TECHNICAL DRAINAGE STUDY ADDENDUM **Durango Beltway Plaza**

Job No.: 103110
Date: August 2018

RE: Addendum to the Technical Drainage Study for Durango Beltway Plaza
Location: SEC of Riley Street and Rome Boulevard
Application #: DS5018

CLV – Review Comments:

DR1

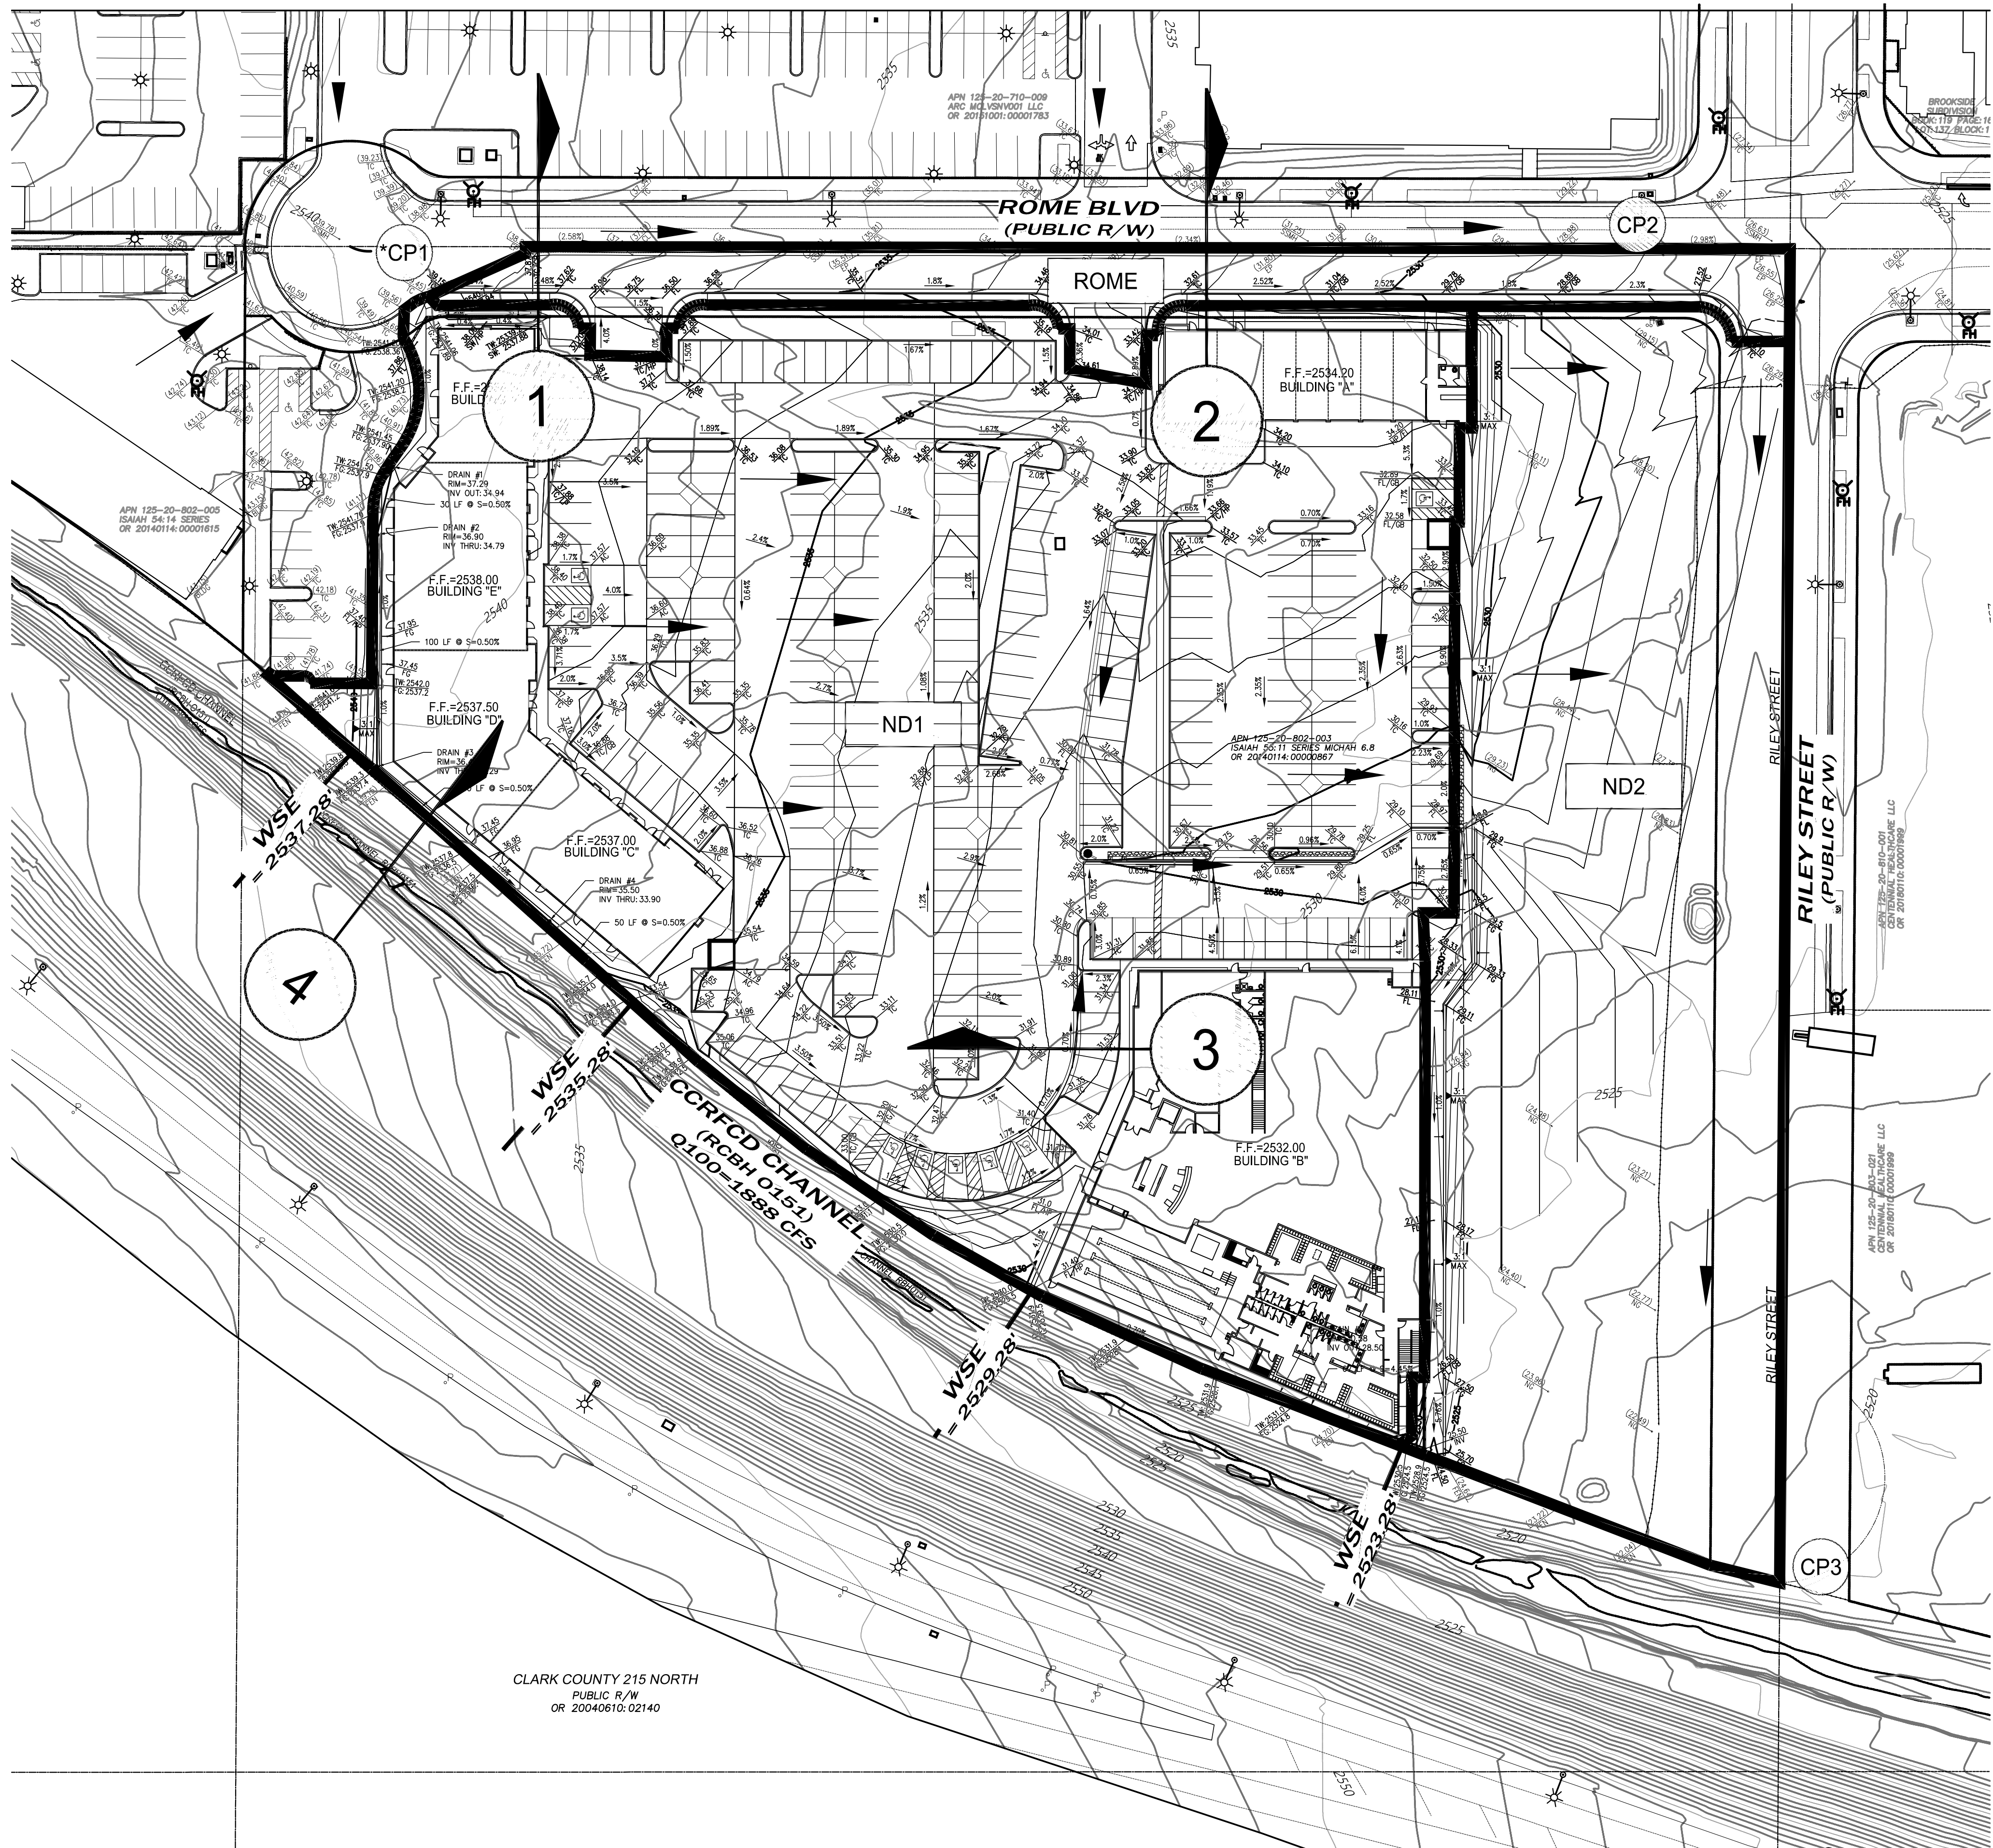
- Sheets DR1 & DR2: Identify and label an existing *Clark County Regional Flood Control District's* facility with Q100 flow. Show the 100-year water surface elevation in the sections of the regional facility corresponding to the buildings ends to verify that adequate freeboards are provided.

Acknowledged. The Q_{100} flow and the Water Surface Elevation (WSE) for the existing CCRFCD facility adjacent to the site has been labeled on the drainage maps (Sheet DR1 & DR2).

SHEET: **G-1**

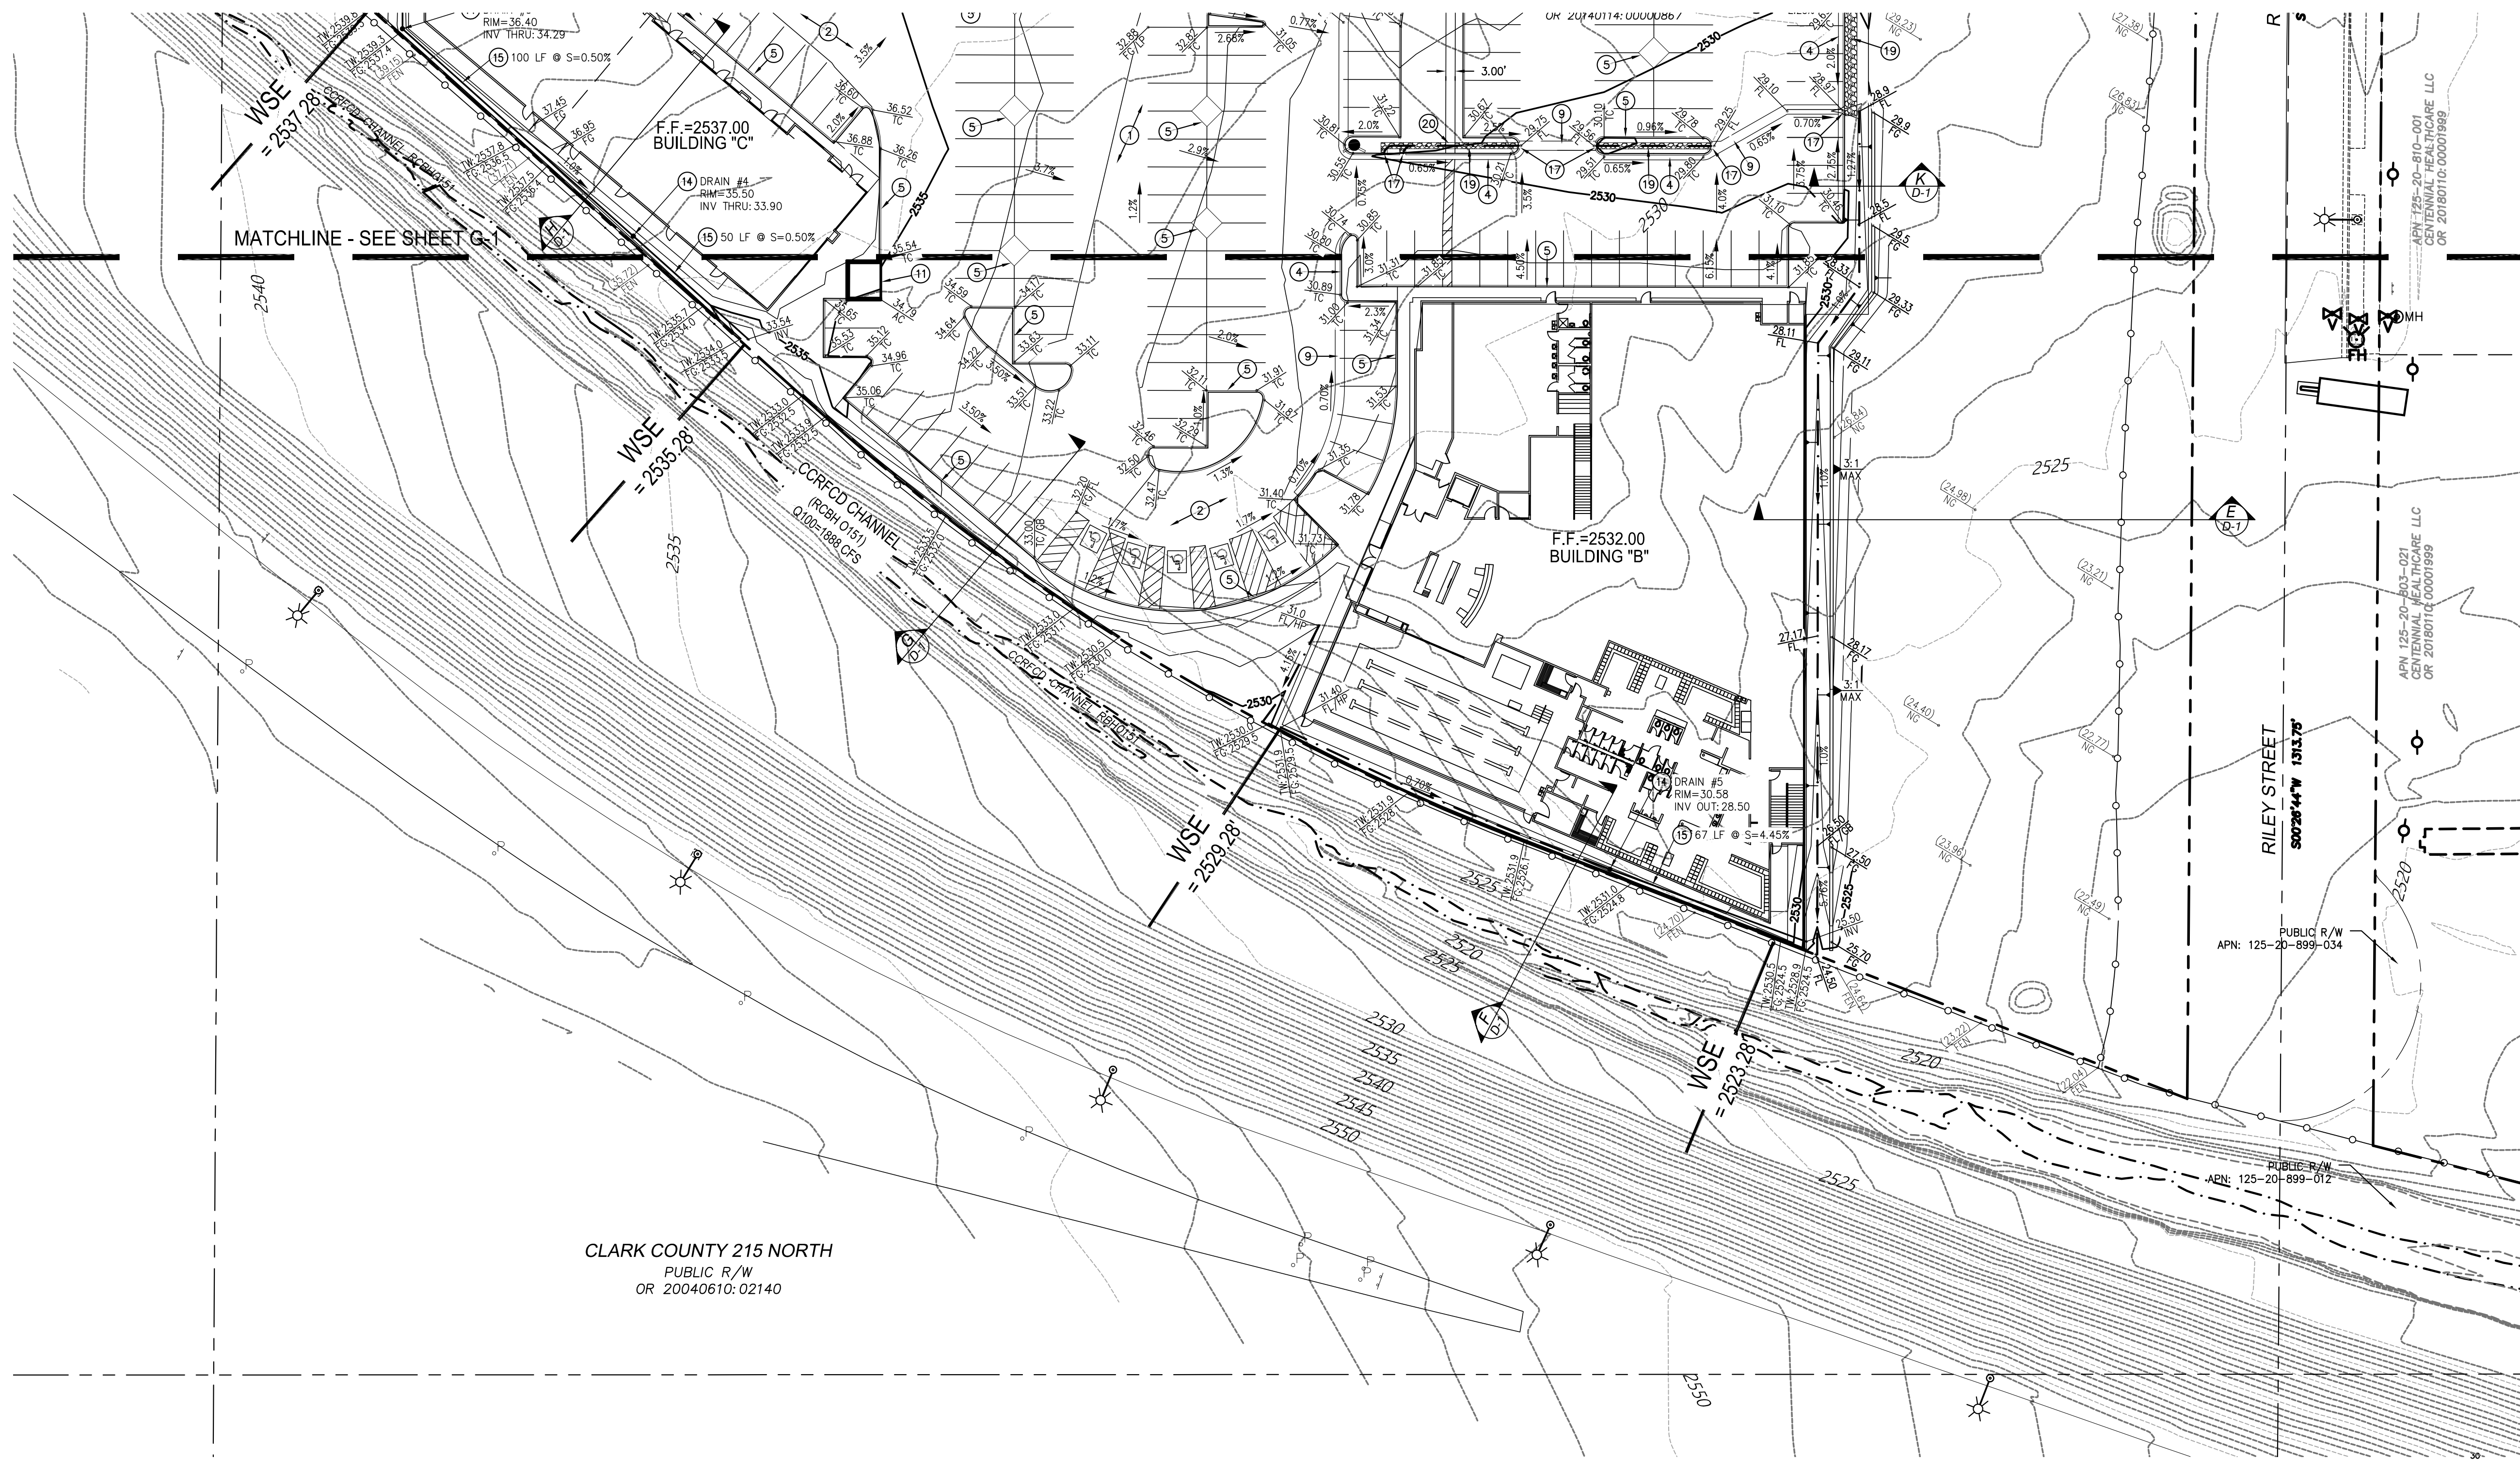
6. Also label the 100-year water surface elevations in the grading plans.

9. Revise all proposed onsite storm drain to a minimum size of 12"-diameter. The proposed 6" will cause frequent clogging and maintenance burden for the property owner in the future.

10. Provide a note on the grading plans: All onsite storm drains and the associated facilities are privately owned and to be privately maintained by the property owner.

Acknowledged. The 100-year WSE have also been labeled on the revised grading plans.

Acknowledged. All the proposed onsite storm drains have been revised to 12"-diameter. Please refer to the revised grading plans provided with this submittal for revised storm drains.

Acknowledged. The grading plans have been revised to include the note as requested. Please refer to the revised grading plans provided with this submittal.

SHEET: **D-1**
5 OF 6

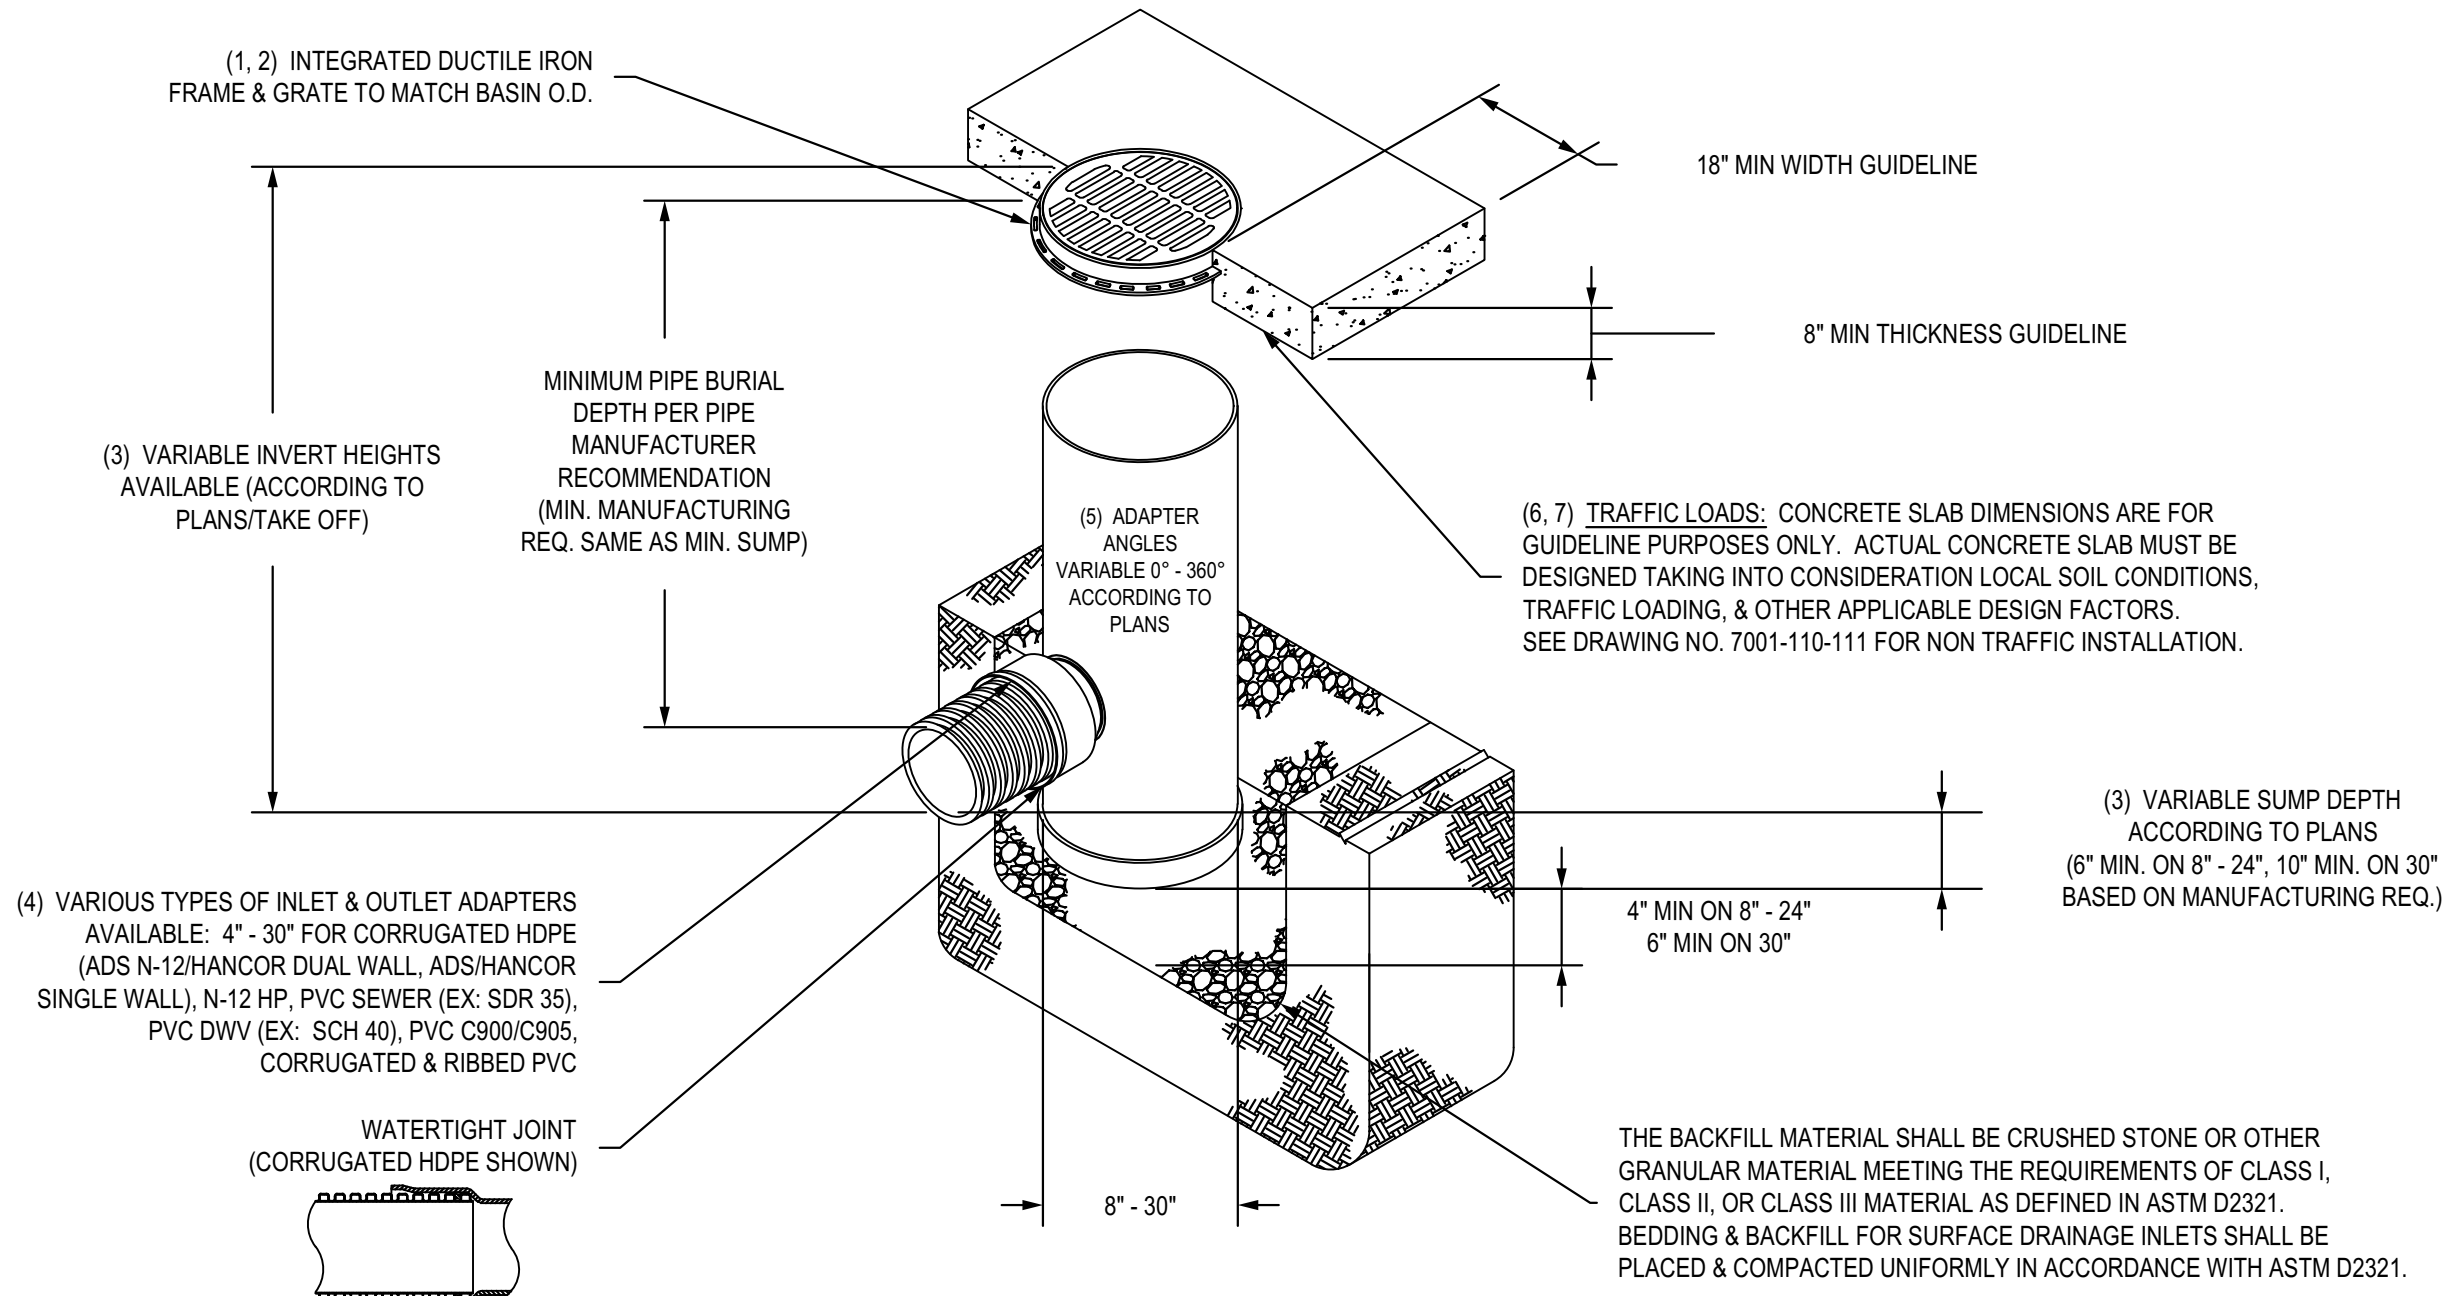
7. A berm is proposed at the back of sidewalk in *Rome Boulevard* for onsite building flood protection. Extend the berm westerly to close the gap with the adjacent driveway entrance. Also raise the height of the berm to 18" instead of 12". Revise the pertinent *Detail Section J/D-1* and all plans and construction notes accordingly.

Acknowledged. The proposed berm has been extended west to close the subject gap and terminate at the proposed western property line wall and has also been raised to 18" high. Detail J/D-1 has been revised accordingly. Please refer to the revised grading plans and detail sheet provided with this submittal.
